# Town of Hilton Head Island **Design Review Board Meeting Tuesday, March 23, 2021 – 1:15 p.m. AGENDA**

# Town of Hilton Head Island **Design Review Board Meeting** March 9, 2021 at 1:15 p.m. Virtual Meeting

## MEETING MINUTES

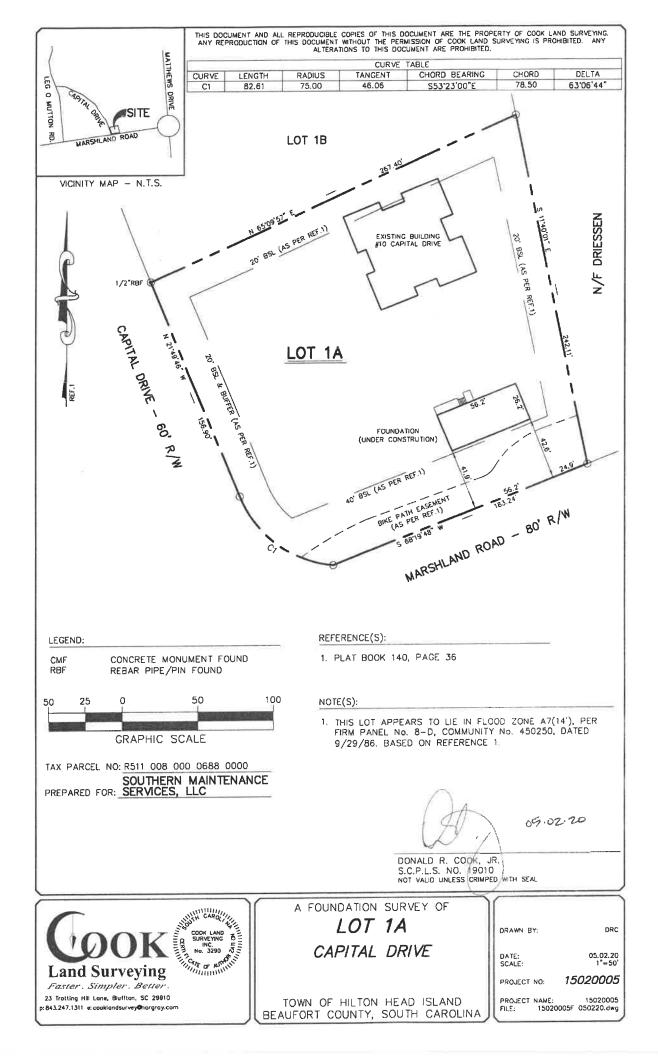
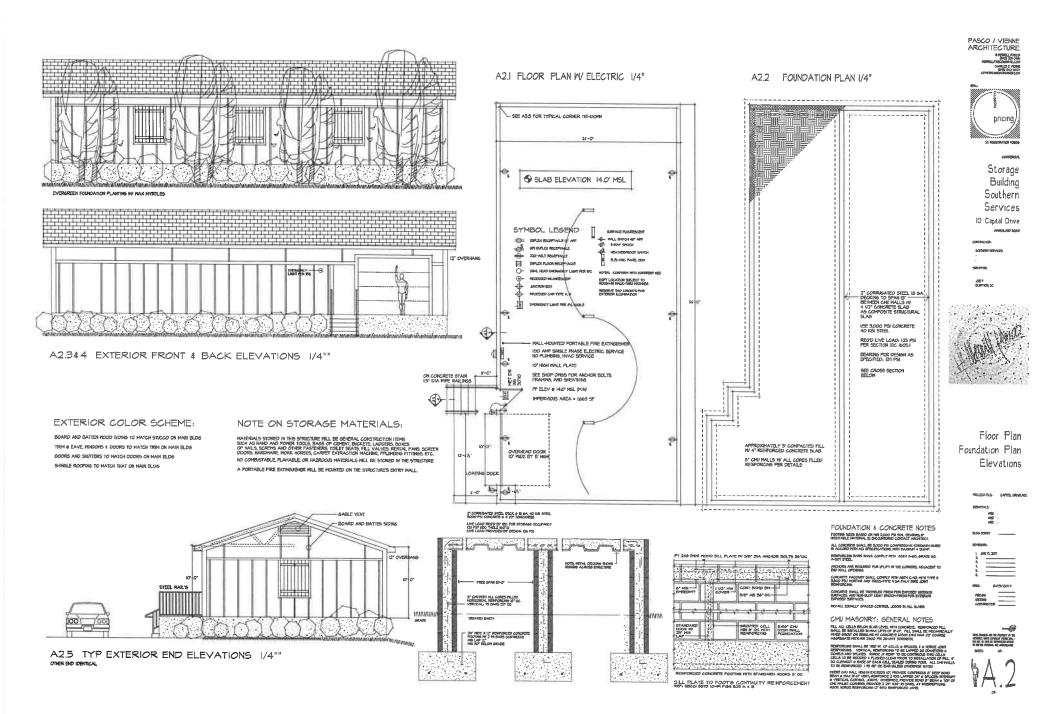
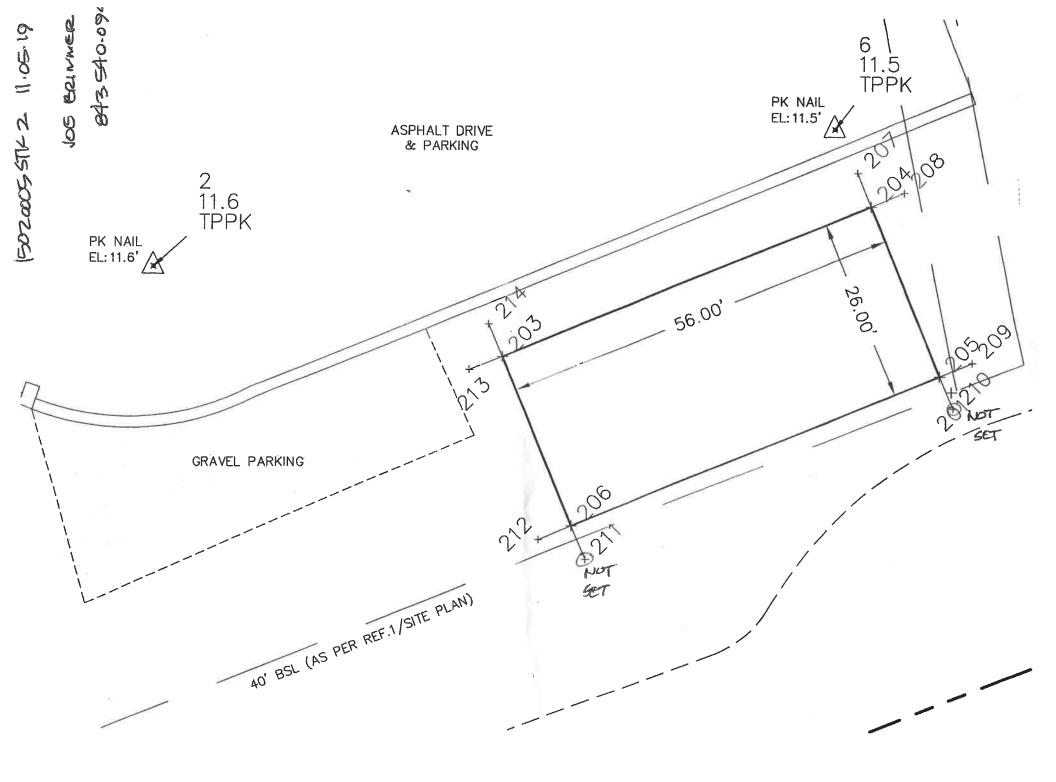
Mr. Darnell presented the application. He explained this application is for alteration to DRB approved permit 2039-2015. He pointed out that these plans were approved prior to hurricane Matthew with construction delayed due to clean-up/repairs from the two hurricanes. He explained that because the building is not visible behind the Marshland Road buffer the applicant is requesting that the stucco finished water table on the building be waived and the cinder blocks be painted the same color as the siding or trim of the building.

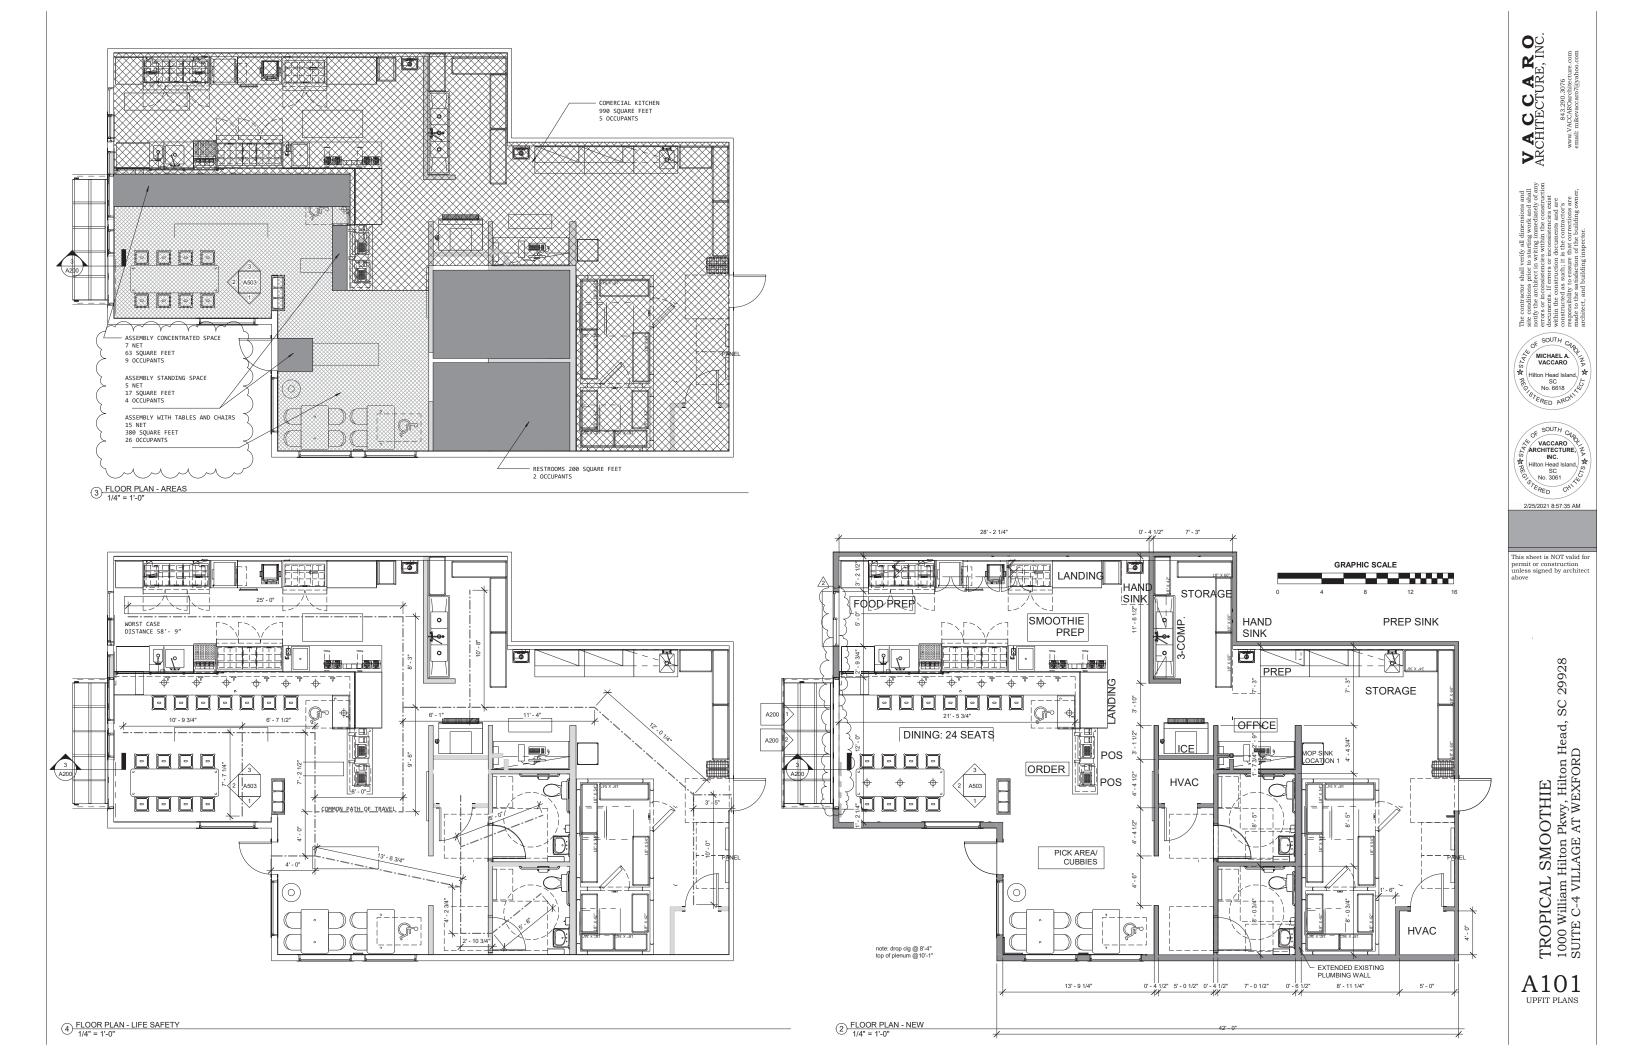
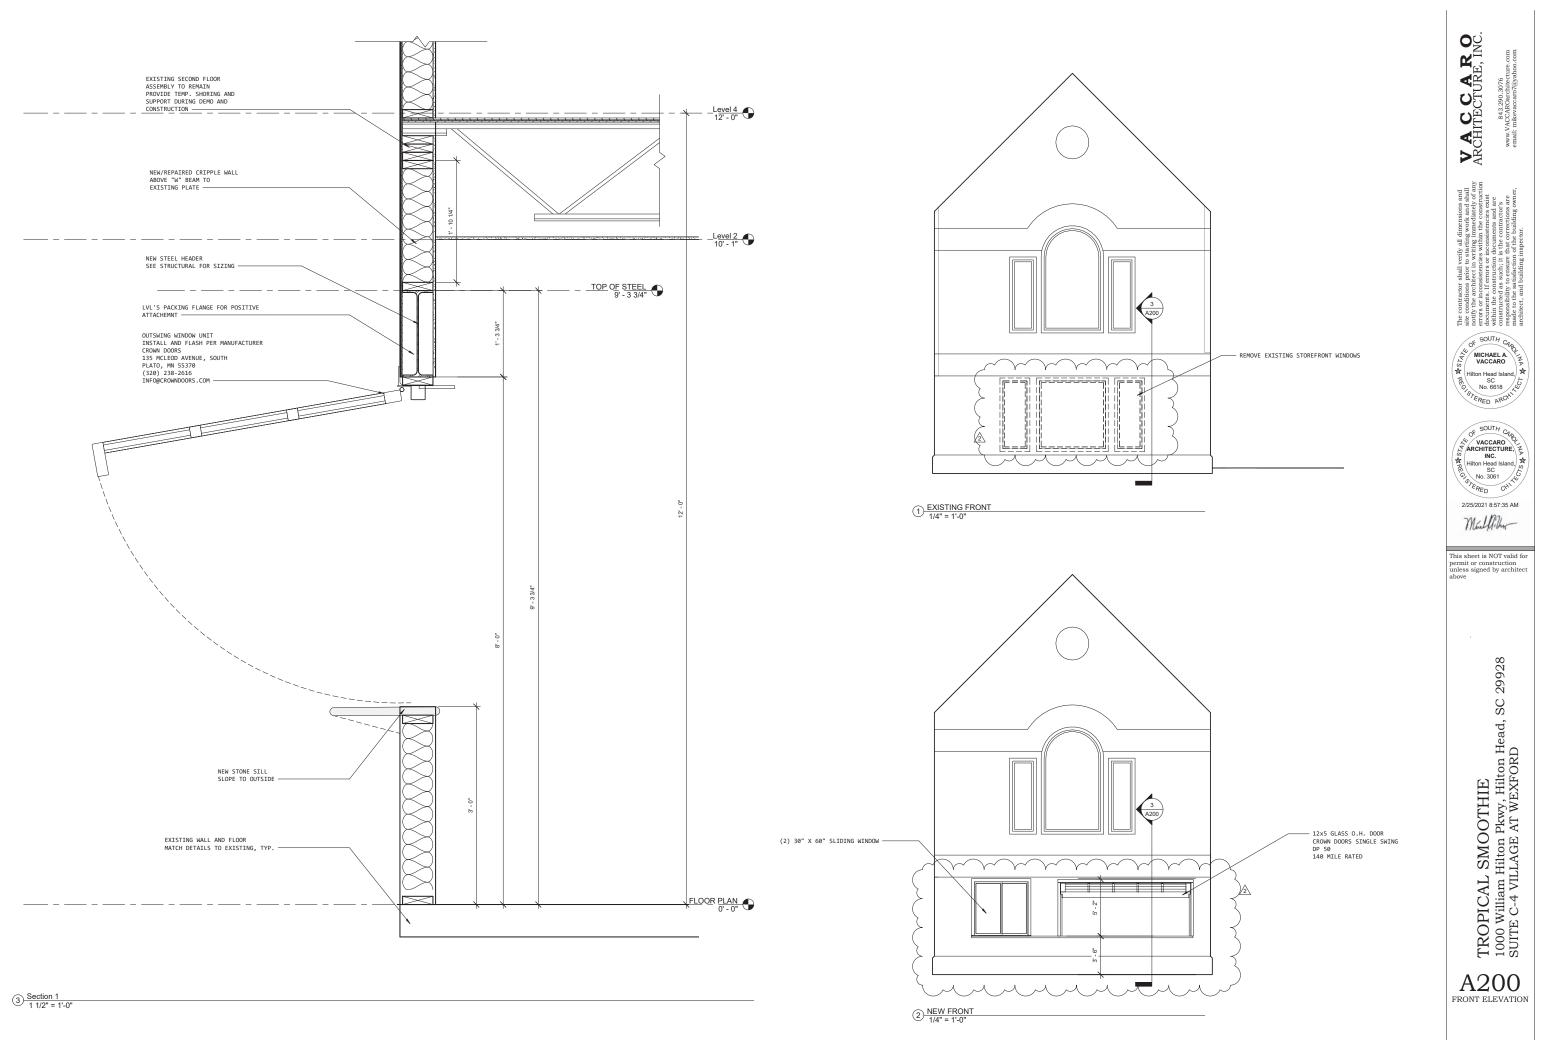
MISC	COMMENTS/QUESTIONS
	Staff suggests that the proposed window or windows placement align with second story window to honor relationship that is repeated around Wexford Village.

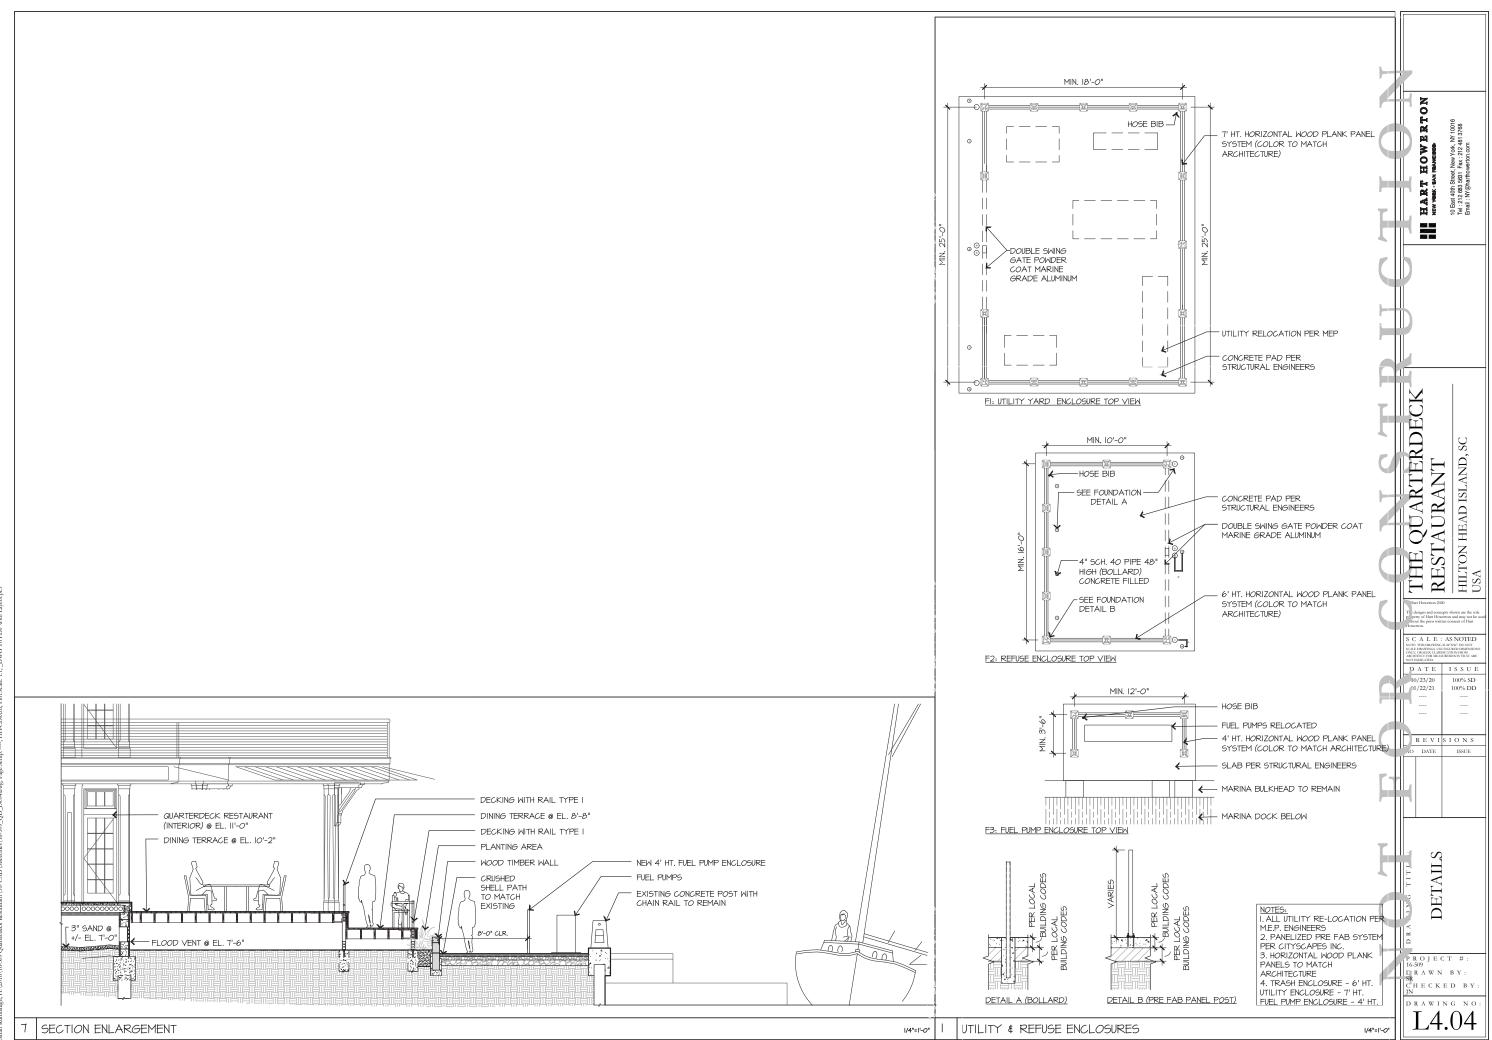
- 2. Detail 4 and 5 on L4.03, review the color of the sign face to change black to a more nature blending bronze.
- 3. Per DRB comments, perimeter walkways to remain the crushed oyster shells.
